Q&A #1

Project: 01B46-13-0254 Exterior walls renovation

Addendum, A-1

Project : Exterior walls renovation – Administration building, Research Centre - CRDBLP
Agriculture and Agri-Food Canada

MODIFICATION AU DESSIN 1/A100
PLAN TOUR EST NIVEAU 1 /
East tower level 1 plan

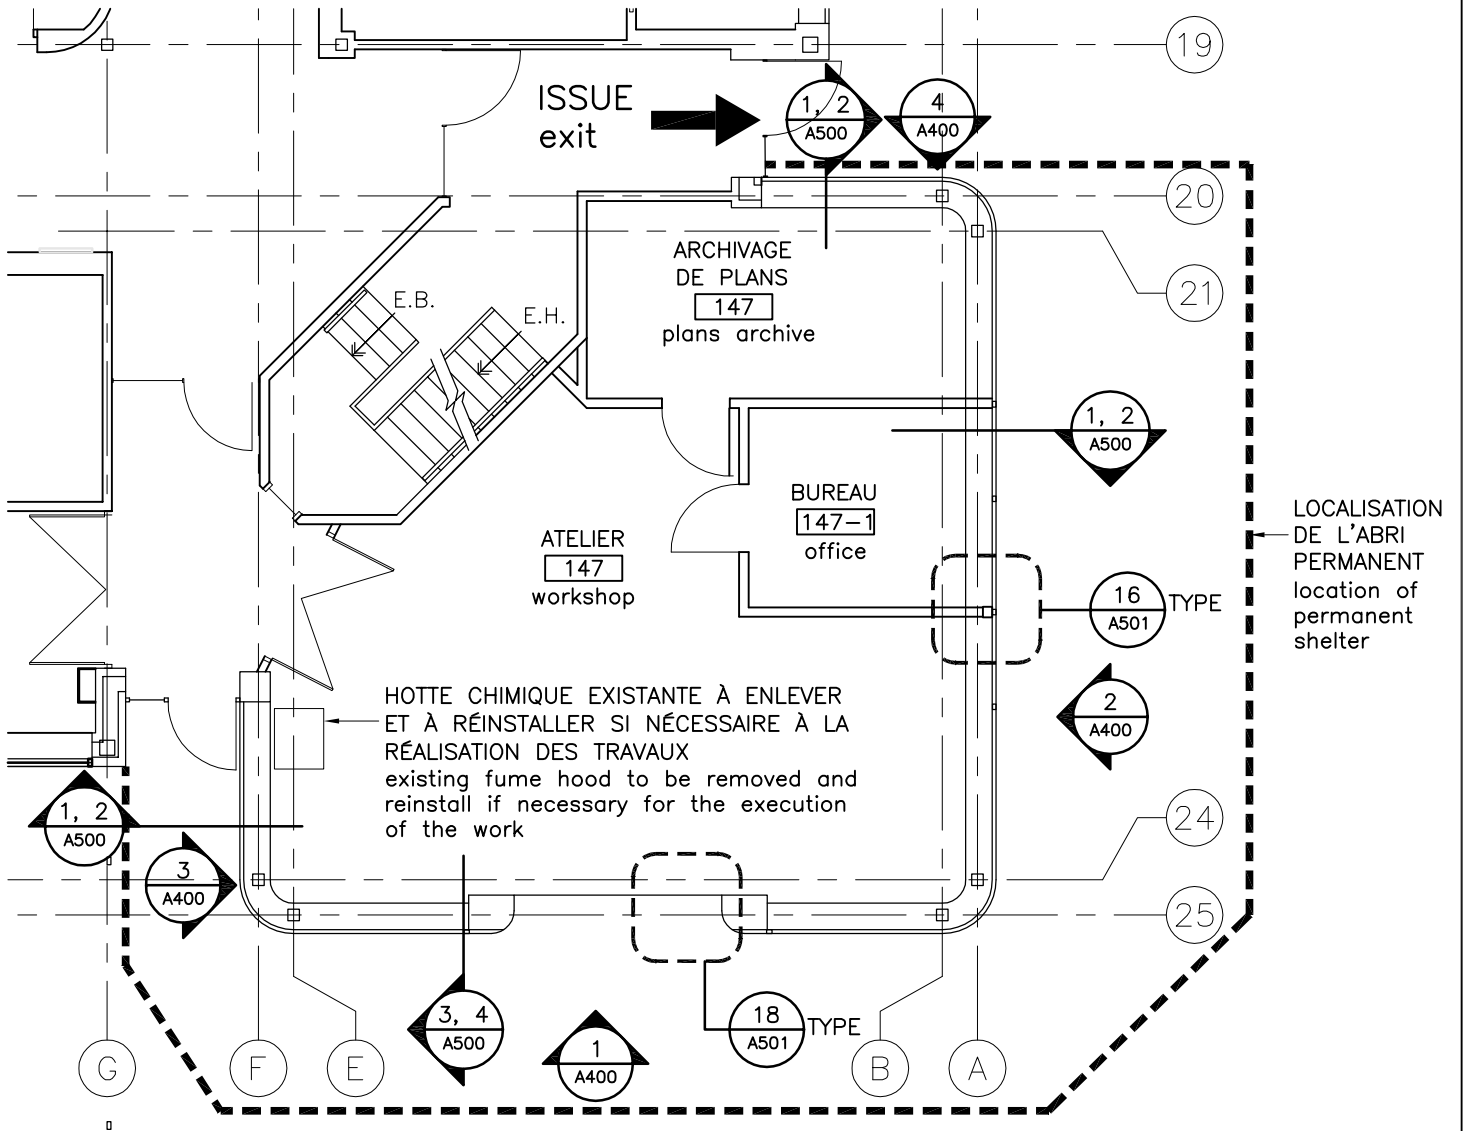
2. Sheet A100, Plans

1. Drawing 1, East tower level 1 plan
 1. See sketch A100-1.
